UPPER UWCHLAN TOWNSHIP
JOINT BOARDS & COMMISSIONS WORKSHOP (4:00 p.m.),
CONDITIONAL USE HEARING (5:30 p.m.)

April 9, 2024
4:00 p.m.

SCHEMATIC
241 PARK ROAD
EAGLE, PENNSYLVANIA 19355

*PRESENTATION PLAN
FOR
241 PARK ROAD*

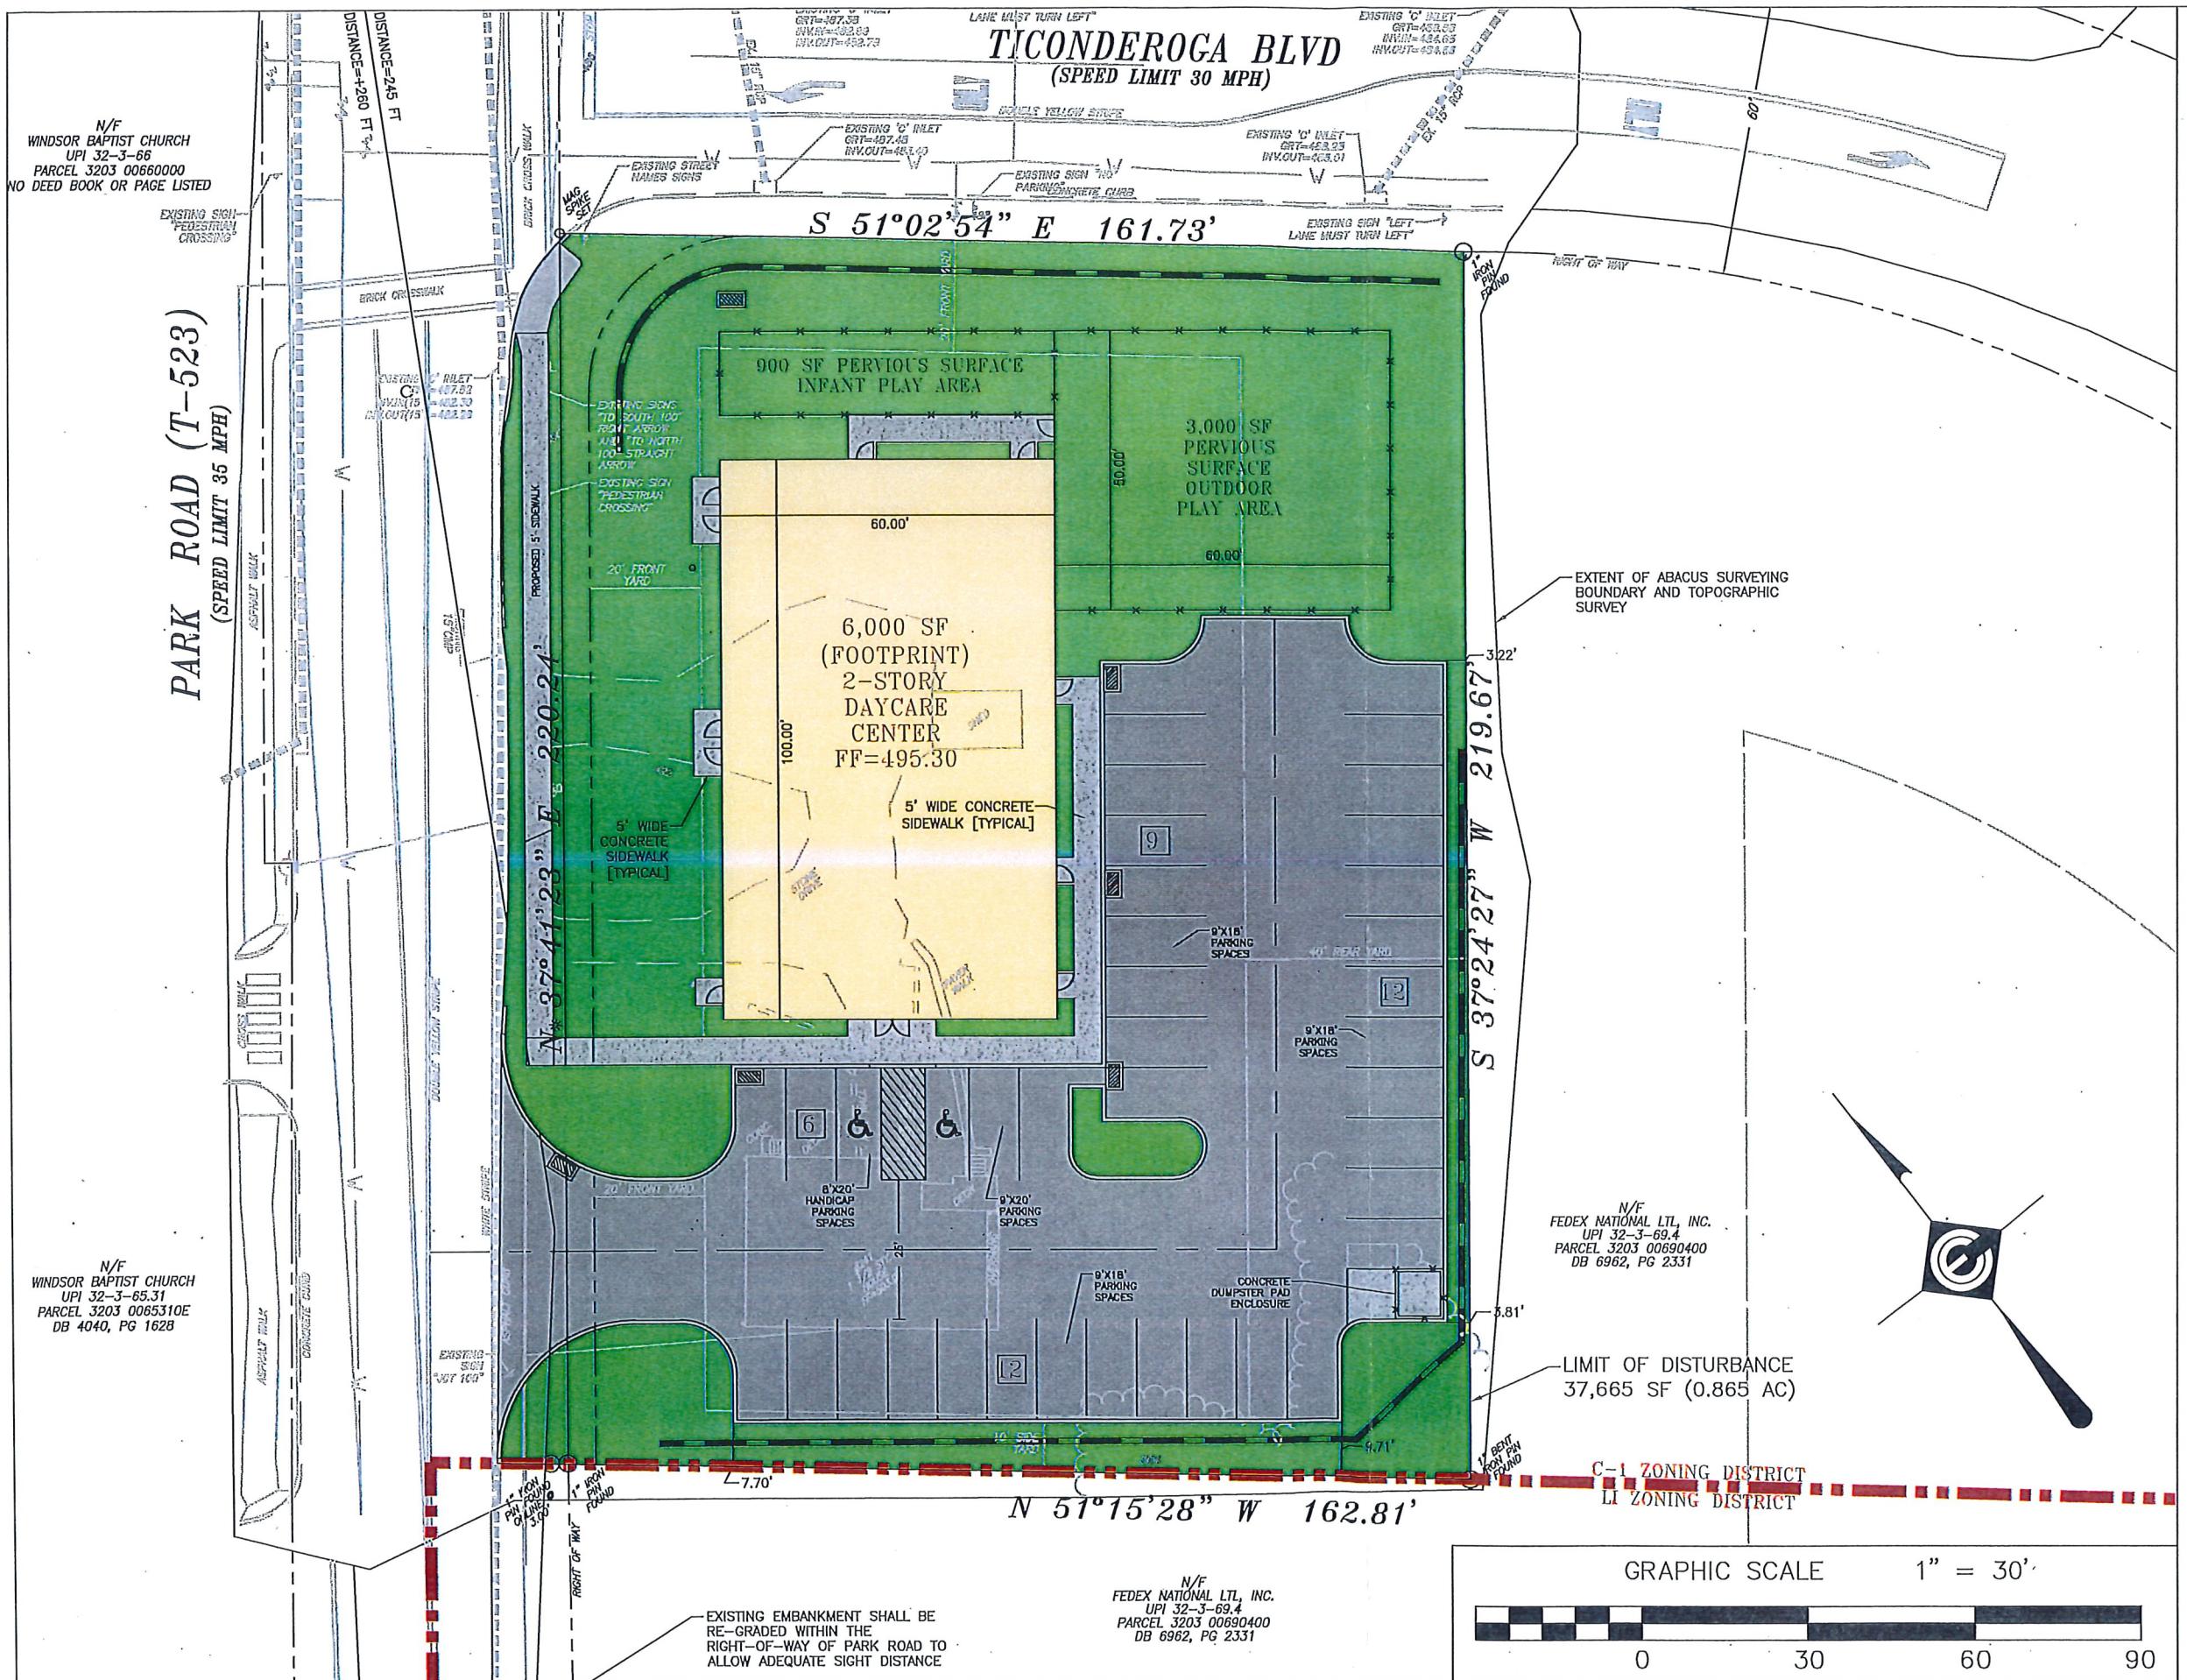
4. §200-36.B.(1)(b) – The architectural rendering indicates a pitched roof. Desired materials on pitched roofs include slate (either natural or man-made), shingle (either wood or asphalt composition), and metal formed to resemble "standing seams." Roof color should reflect local traditional use of color, and shall specifically exclude white, tan, or blue shingles, red clay tiles, and corrugated metal or other corrugated material. The use of fascias, dormers, and gables is encouraged to provide visual interest. The applicant shall provide information on the roofing to show compliance with these requirements.

6. §200-36.B.(1)(d) – All facilities and equipment for heating/air conditioning, trash collection and compaction, and other structural elements not in keeping with historical architectural themes shall be concealed architecturally or otherwise screened from view from any public right-of-way or public space. The applicant shall clarify where HVAC equipment is located to determine if screening is required. A fence detail shall be provided for the fence surrounding the outdoor play areas. Note that two (2) Grading Plan sheets were included with the submission which show the dumpster location in different spots; the applicant shall clarify which Grading Sheet is intended to be part of the plan set. The Dumpster Enclosure Detail (Sheet 7) includes the note “The applicant may utilize an alternate privacy fence the dumpster with the approval of the township engineer” which should be removed.

7. §200-36.B.(2) – For all principal uses permitted by conditional use approval, applicant shall provide drawings of sufficient detail to illustrate the character of the intended exterior design of structures, including scale, height, roof pitch, relationship between varying facade elements, and principal exterior materials. The Township may require that material samples also be provided. It shall be the burden of the applicant to demonstrate that submitted architectural designs are consistent with, and promote, the purposes and standards set forth for the C-1 Village District.

1 Elevation

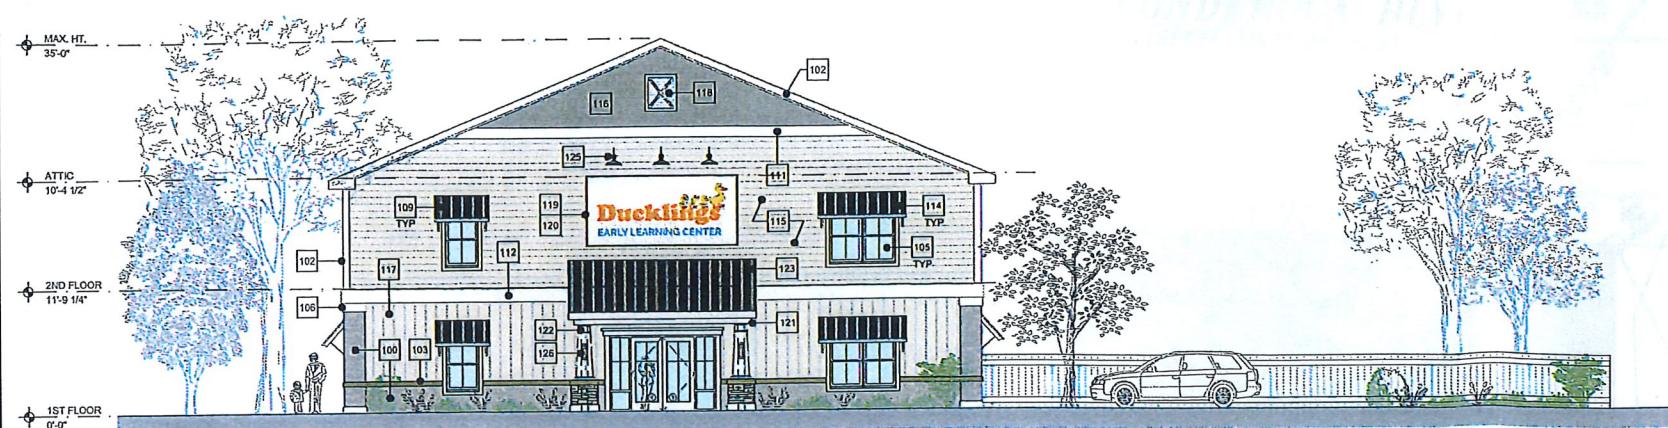
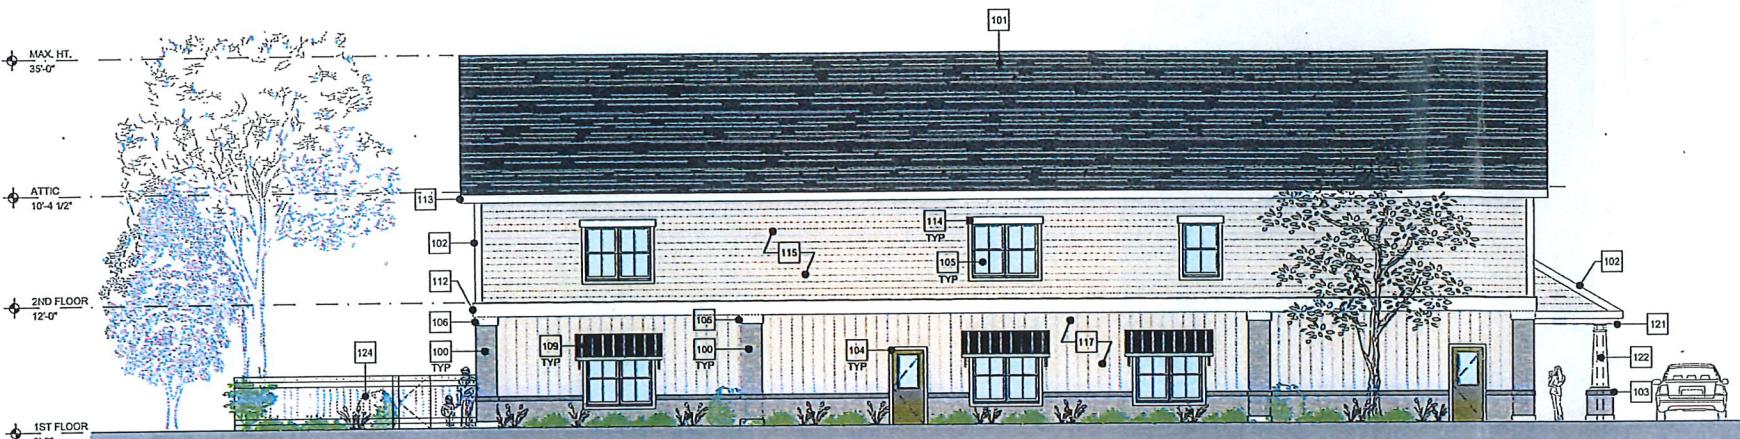
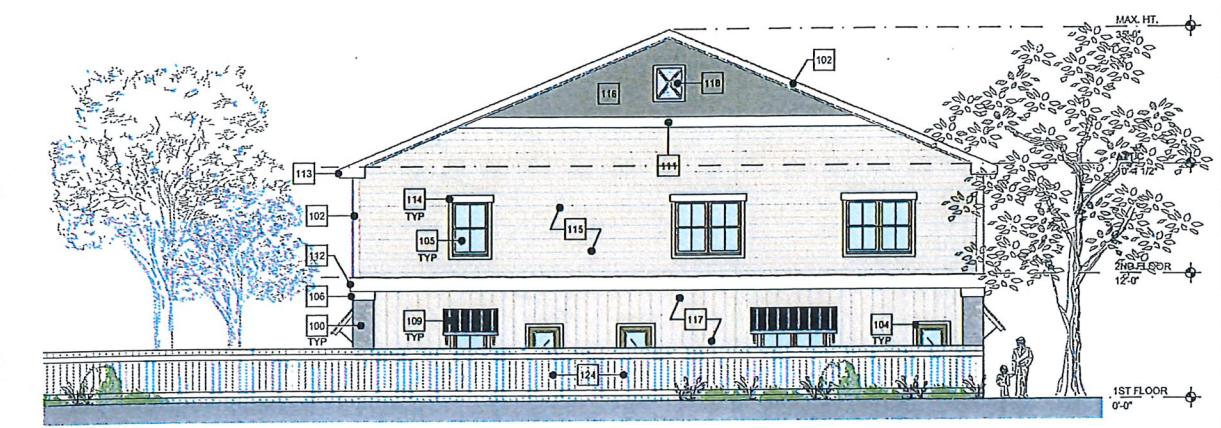
5. Request that Planebrook Partners, LLC demonstrate that its submitted architectural designs for the proposed daycare center are consistent with, and promote, purposes and standards set forth for the C-1 Village Zoning District, including, but not limited to, by providing more details about proposed design and sample materials.
6. Request that Planebrook Partners, LLC provide more information on the proposed signage and exterior building art (duck tracks) to determine if it complies with the C-1 Village Zoning District signage requirements under Ordinance Section 200-98H and other applicable signage sections.
